CNL-16-170

Clinch River Nuclear Site
NRC Project No. 785

Subject: Submittal of Supplemental Information Related to Vibratory Ground Motion in Support of Early Site Permit Application for Clinch River Nuclear Site

SUPPLEMENTAL INFORMATION RELATED TO VIBRATORY GROUND MOTION OF THE EARLY SITE PERMIT APPLICATION FOR CLINCH RIVER NUCLEAR SITE

Figure 2.5.2-56. Shear Modulus Reduction and Damping Curves for Firm Rock

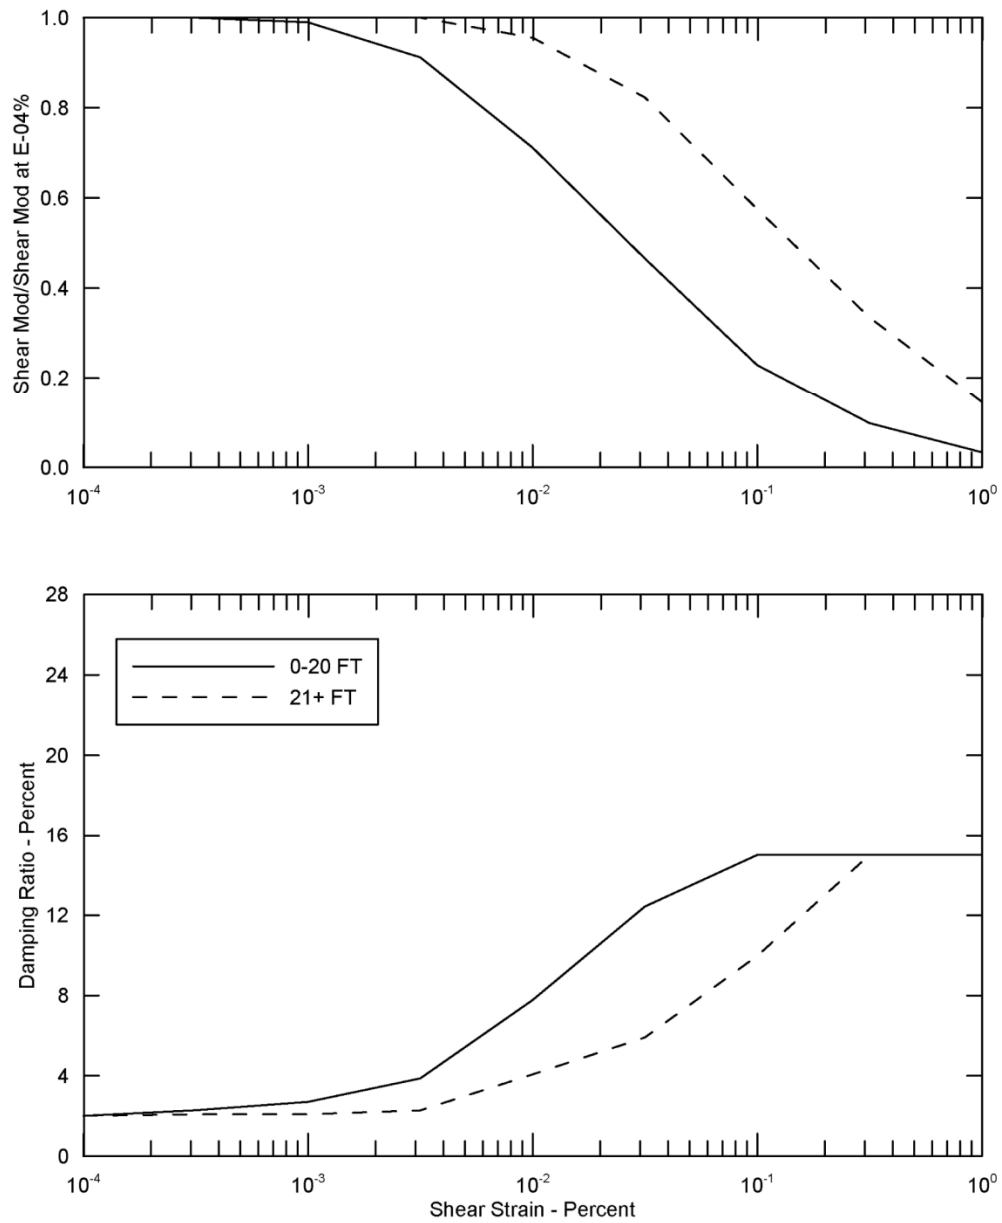
To accommodate potential loading level dependencies on shear-wave velocities and hysteretic damping within the shallow sedimentary rock column at the CRN Site, a modified subset of the EPRI rock modulus reduction and hysteretic damping curves (Reference 2.5.2-142) was used (Figure 2.5.2-56) along with equivalent-linear site response analyses. The curves were

Figure 2.5.2-96. Clinch River and TVA Damsite V_s Profile Sigmas

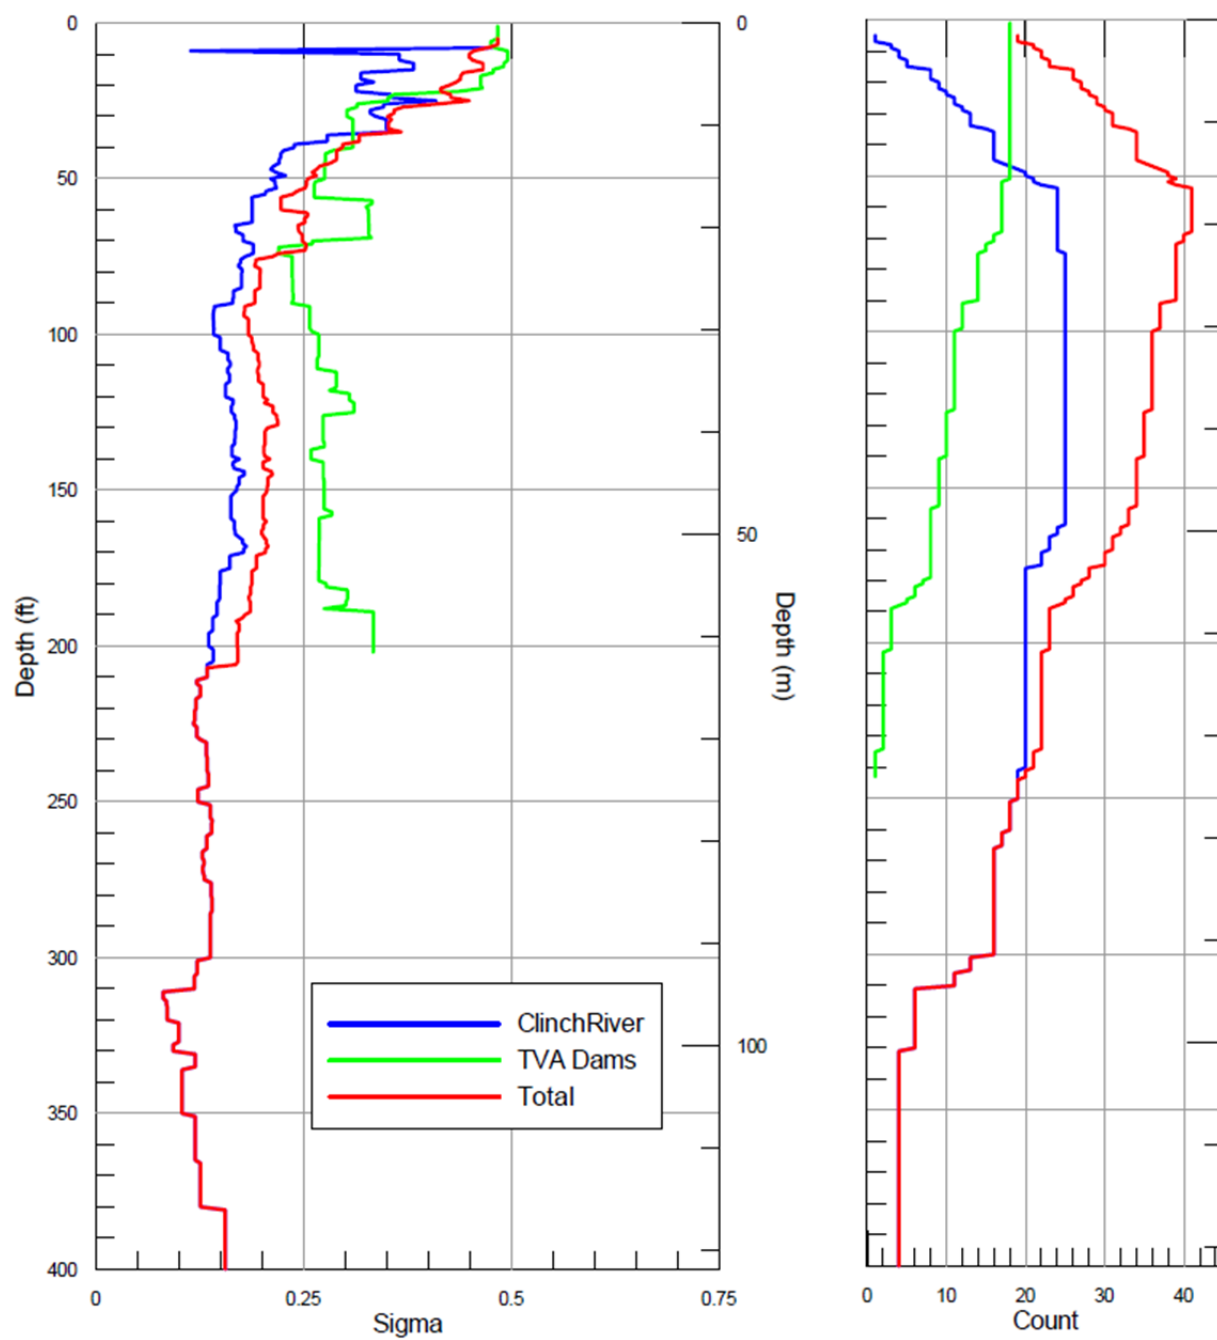
Using these results as well as the sigma across units at the CRN Site in Figure 2.5.2-96 to inform judgment in developing depth-independent epistemic uncertainty, a standard deviation of 0.15 was selected to accommodate potential 2D effects in the top 300 ft where 2D effects may be expected to be the strongest in the shallow strata but still minor, as well as lack of site-specific measurements below a depth of about 300 ft. Considering a three-point approximation to the distribution weights of 0.2, 0.6, and 0.2 for lower (P2)-, middle (P1)-, and upper (P3)-range estimates results in a velocity scale factor of approximately 1.25, a $\pm 25\%$ variation about the mean (best estimate) basecase. The resulting base-case (P1) as well as lower-range (P2) and upper-range (P3) basecases are illustrated in Figure 2.5.4-20 and 2.5.4-21 for Locations A and B, respectively. The resulting range in V_s from the lower- to upper- base-cases is about 1.6 and well within the range for such materials (Reference 2.5.2-208), acknowledging a portion of the range was taken to accommodate the dipping structure.

Figure 2.5.2-101. Interpreted shear-wave velocity at Tellico Dam. Velocity from suspension log in Boring TLH-4

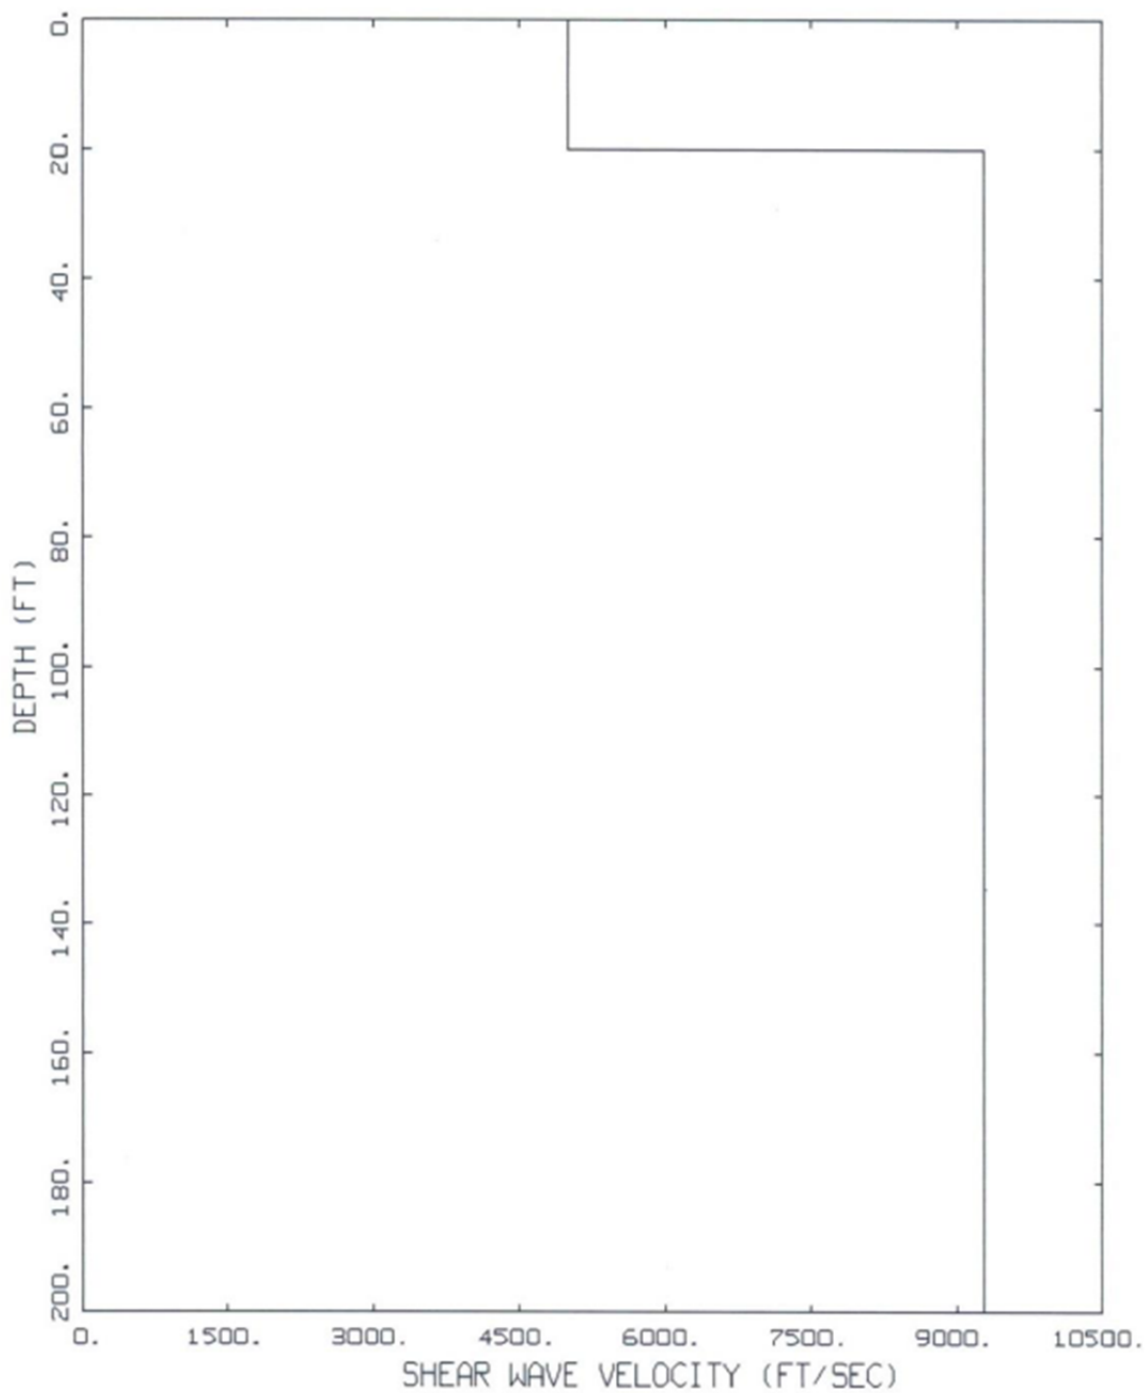
Figure 2.5.2-101 shows the smoothed and interpreted V_s at the site based on the OYO suspension logging. The top 6.1 m (20 ft) of soil and weathered rock is represented as a single layer with a V_s of 1,524 m/s (5,000 fps) overlying hard rock with a V_s of 2,830 m/s (9,285 fps).

Figure 2.5.2-102. Smoothed Tellico Dam crustal transfer functions for local crustal model with a surface shear-wave velocity of 1,524m/s in the top 6.1m (20 ft) over hard rock (2,830m/s)

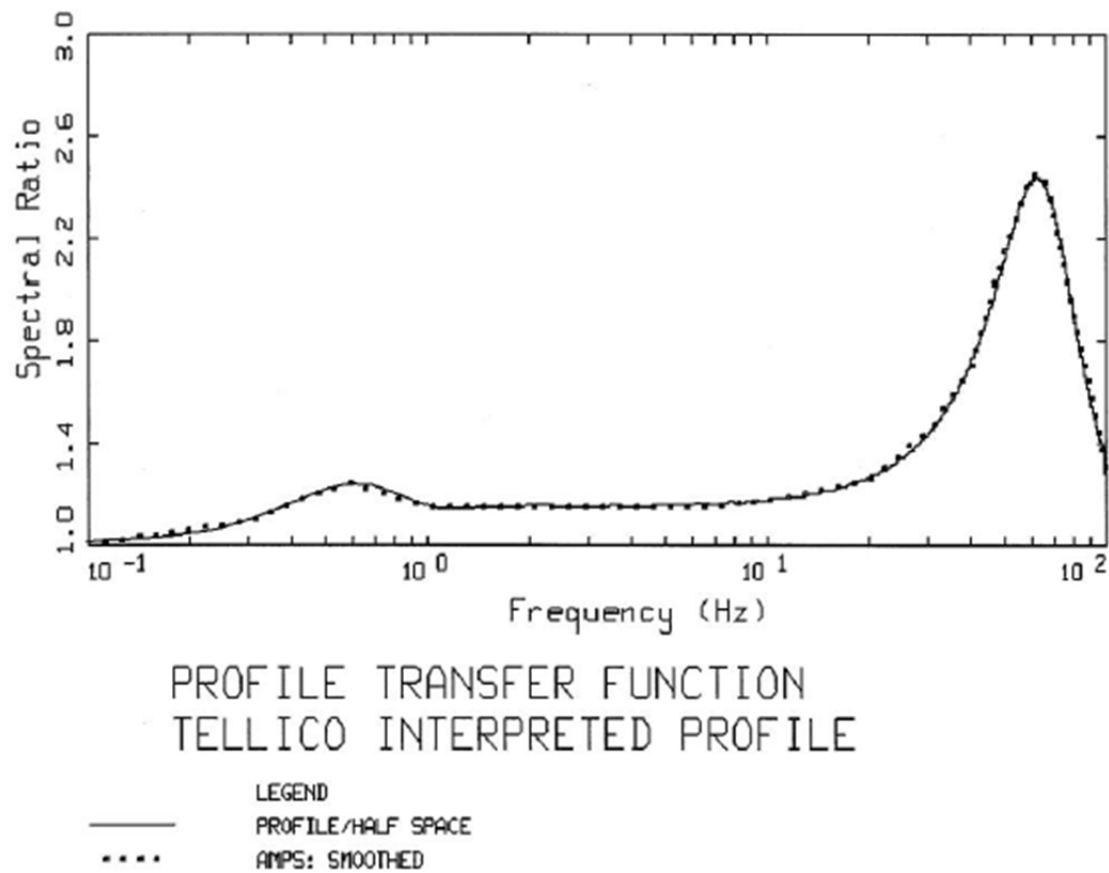
The presence of the relatively thin layer of shallow soil and weathered rock over hard rock was expected to dominate and distort the high-frequency amplification, resulting in a biased estimate of kappa (Reference 2.5.2-179). To correct for the presence of high-frequency distortion, amplification from the shallow crustal profile was estimated from the interpreted V_s profile (Figure 2.5.2-101) from source depth to the surface. The relatively high V_s and depths in the structure beneath the shallow soil and weathered rock, which reflect low-frequency resonances (Figure 2.5.2-99), was not expected to affect estimates of kappa (Subsection 2.5.2.5.4). The smoothed linear (damping 0.01%) transfer function as implemented (Subsection 2.5.2.5.2.3.1) is shown in Figure 2.5.2-102 and is dominated by a high-frequency (near 60 Hz) resonance caused by the 6.1m (20 ft) soil and weathered rock layer over the hard rock layer. The peak amplification is around a factor of 2.5.

Figure 2.5.1-30. Geologic Cross-Section K-K' of the Clinch River Nuclear Site

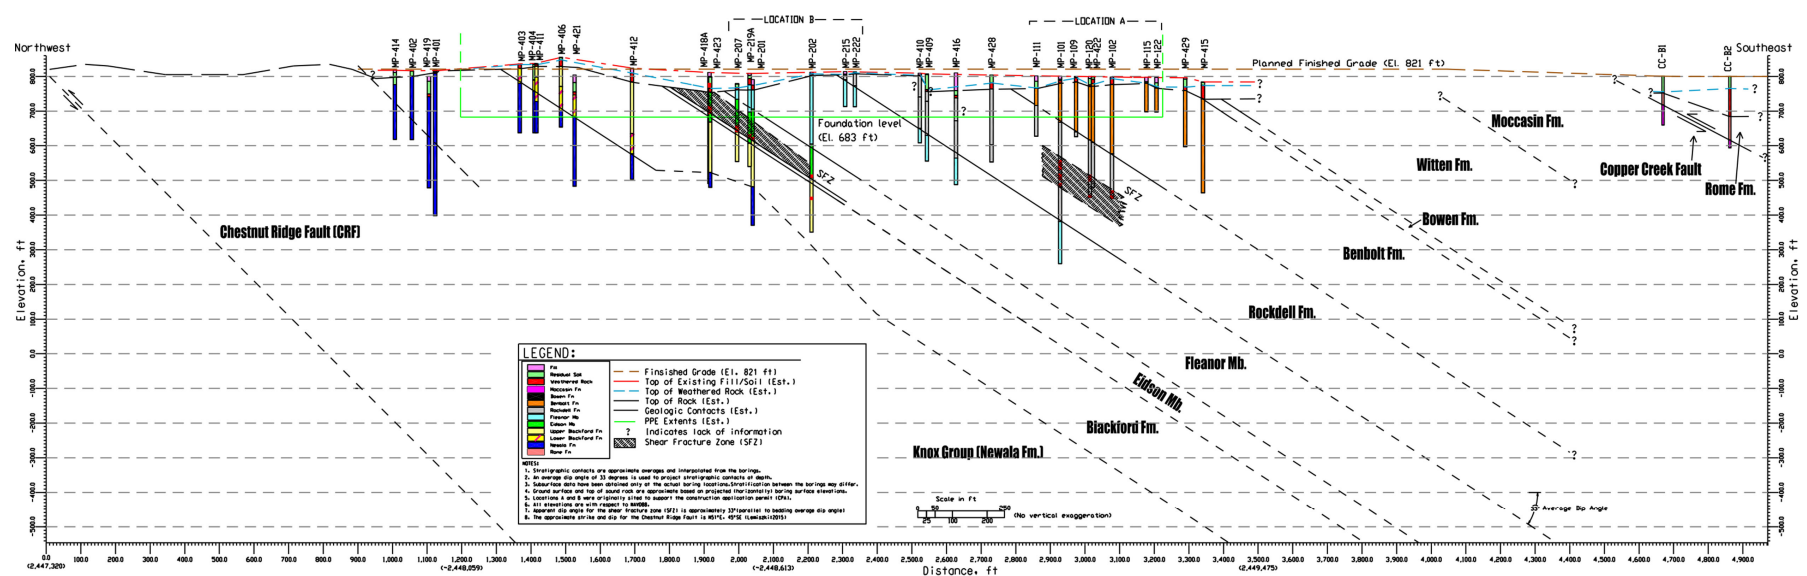
The cross section in Figure 2.5.1-30 is revised to include the Chestnut Ridge fault as well as the Shear Fracture Zone.
